Access Compliance Report

Public Rights-of-Way

(Curb Ramps)

Intersection ID: N/A	Main Street: E_STONEWALL_ST	Cross Street: S_MCDOWELL_ST	Location: W
ADA ID: 490C33956B30	Ramp Type: PerpDiag	Initial Pass/Fail: Fail	Overall Compliance: No
		Severity Score: 37.5	
Codes/Mitigation Info/Possible Solution		Field Measurements/Component Compliance

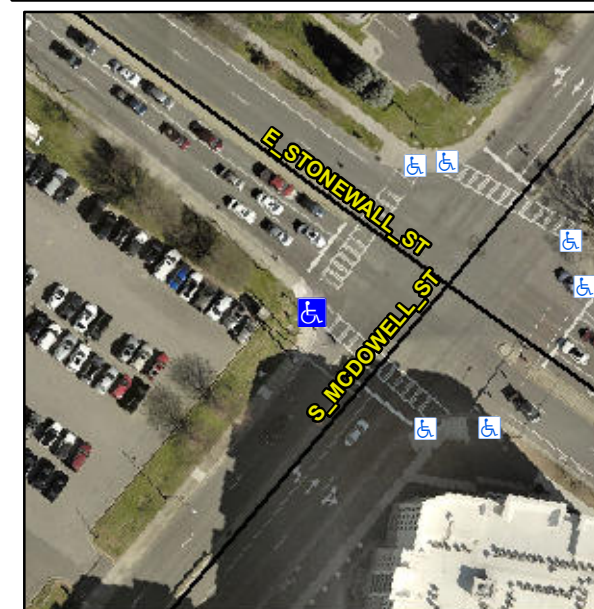
Not Found, R304.2.2, R304.5.3

Compliance	Description	Data	Compliance	Description	Data
N/A	Ramp Length (in)	72.0	No	Ramp Slope (%)	9.0
Yes	Ramp Width (in)	48.0	No	Ramp XSlope (%)	7.5
N/A	Flare Type LT	N/A	N/A	Flare Type RT	N/A
N/A	Flare Slope LT (%)	N/A	N/A	Flare Slope RT (%)	N/A
N/A	Flare Traversable LT?	No	N/A	Flare Traversable RT?	No
N/A	Landing Length (in)	N/A	N/A	DWS Provided?	N/A
N/A	Landing Width (in)	N/A	N/A	DWS Contrast?	N/A
N/A	Landing Slope (%)	N/A	N/A	DWS Length (in)	N/A
N/A	Landing X Slope (%)	N/A	N/A	DWS Full Width?	N/A
N/A	Landing Curb? (Y/N)	N/A	N/A	DWS Offset (in)	N/A
N/A	Shared Landing?	N/A			
N/A	Gutter Ponding?	N/A	N/A	Gutter Slope (%)	N/A
N/A	Gutter Lip Ht (in)	N/A	N/A	Gutter X Slope (%)	N/A
N/A	Painted X Walk1?	Yes	N/A	Painted X Walk2?	Yes
	X Walk 1 Direction	To SE		X Walk 2 Direction	To NE
N/A	X Walk 1 Width (in)	103.0	N/A	X Walk 2 Width (in)	119.0
	X Walk 1 Slope (%)	7.3		X Walk 2 Slope (%)	4.2
	X Walk 1 X Slope (%)	5.5		X Walk 2 X Slope (%)	1.1

N/A	Ramp inside XWalk1?	Yes	N/A	Ramp inside XWalk2?	Yes
	Road Slope (%)	7.0	N/A	Clear Space?	N/A
	Road X Slope (%)	1.9	N/A	Clear Space to XWalk (in)	N/A
N/A	Any Obstructions?	N/A	N/A	Storm Grate/Utility Hazard?	N/A
	Obstruction Type			Storm Grate/Utility Type	
		N/A			N/A
		Yes		Surface Condition? (G/P)	Good

Remove & Replace Curb Ramp With Two New Directional Ramps or Equivalent.
